SERVICE SUPPORT DOCUMENT

Program Type	SERVICE UPDATE PLAN #3010
Product Type	2213,2215
Service Support Group	BEAVERTON SERVICE SUPPORT

SERVICE UPDATE PROGRAM 3010I. PROGRAM OVERVIEW

2213/2215 CRT FILAMENT VOLTAGE

FIG 1

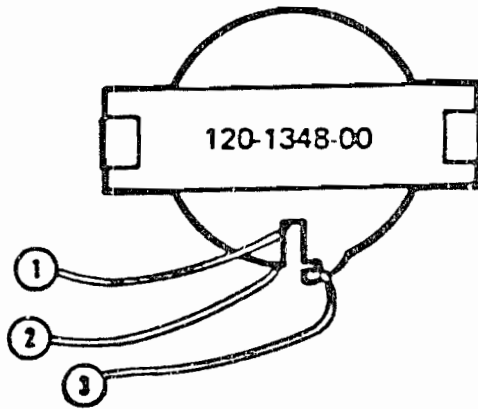
- () 17. Locate the lead of T940 labeled (3) in Fig. 1. Unsolder this lead from the Main circuit board, noting location for later reassembling.
- () 18. Unhook wire (3) from small retaining clip in transformer bobbin and unwind one complete turn. Refer to Fig. 2.
- () 19. Snap wire back into the retaining clip and pull tight.
- () 20. Cut off 3 inches of lead. Trim 3/16 inch insulation off remaining lead. Take care not to nick or cut the wires.
- () 21. Dress wire (3) back through the transformer core as indicated in Fig. 3.
- () 22. Tin the stripped lead and resolder it to the Main circuit board pad, noted previously. The dress of the wire is not critical except it should not be pulled tight against the edge of the transformer core.
- () 23. Change the part number on top of the transformer from 120-1340-00 to 120-1348-01.

FIG 3

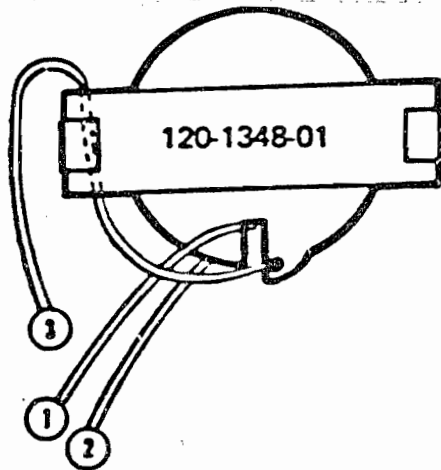
The customer letter and instructions will not include this label. Therefore, each customer unit coming through the service center must be examined to verify whether or not it needs to be modified. Identification can be made either by the transformer part number upgraded to 120-1348-01 or the transformer lead being redressed as per Figure 3 of the mod instructions.

T940 Heater Voltage Winding Modification.

M50226

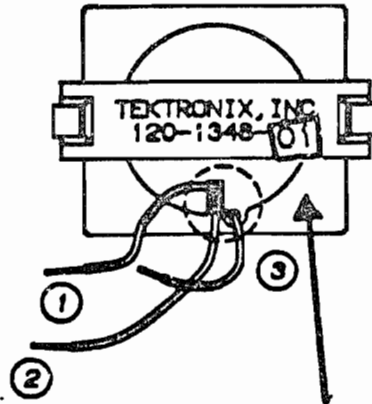
If the unit has already been modified, add the "M50226" tag. If the unit has not been previously reworked, perform the mod and apply the tag.

APPLY THE TAG IN THE LOWER LEFT CORNER (as viewed from the rear) OF THE METAL REAR SUBPANEL. The tags will not stick securely on the plastic back panel. Place the tag on the metal subpanel lower left corner so that the tag will be visible through the slotted vent in the plastic rear panel.

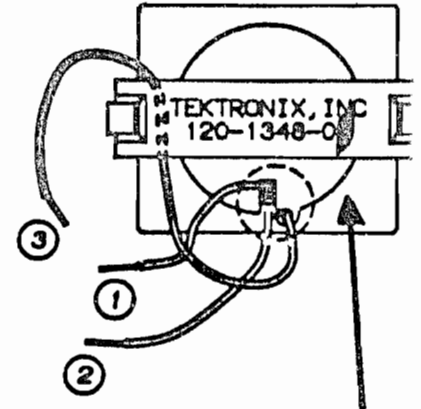
A few modified units had the wire redressed as the original part after being moded. Look for the "01" part number.

The "00" was changed to "01" with a white stick on label.

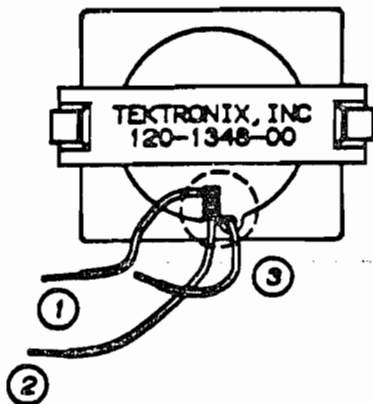
The last "0" in the P was changed to a "1" with a black felt tip marker.

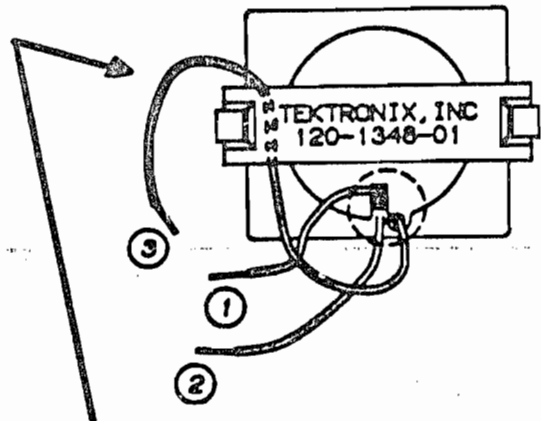
Wire # 3 in UNMODIFIED units goes directly from the notch to the circuit board connection.

Wire # 3 in a MODIFIED unit is looped through the transformer bobbin and then resoldered to the same circuit board connection point.

Wires # 1 and 2 are not changed. They remain connected as before the mod.

2200 SERIES FILAMENT VOLTAGE MODIFICATION

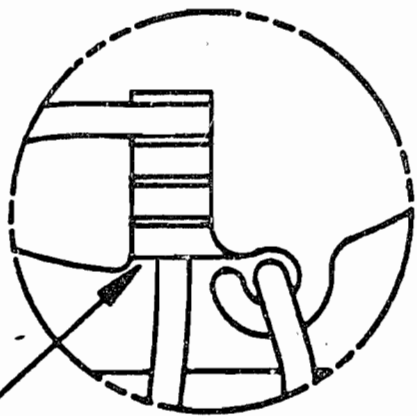
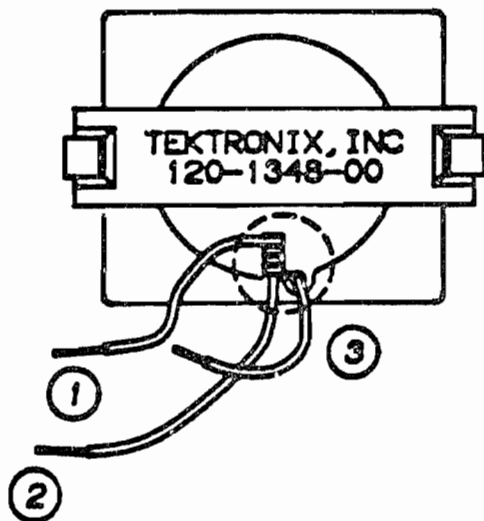
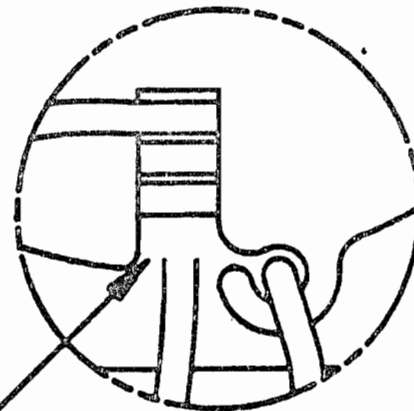
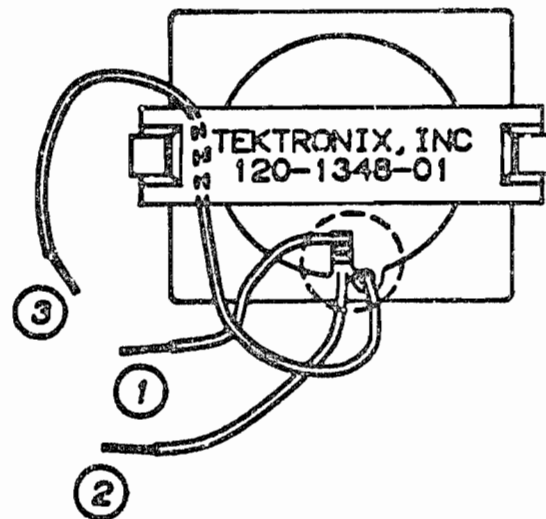
FIGURE 1
(BEFORE MODIFICATION)

FIGURE 2
(AFTER MODIFICATION)

Close examination of the notch in the top of the transformer should show the space left when the first wrap is unwound during implementation of the modification. (FIG 2) An unmodified transformer will show the wires all the way out to the edge as in FIGURE 1.
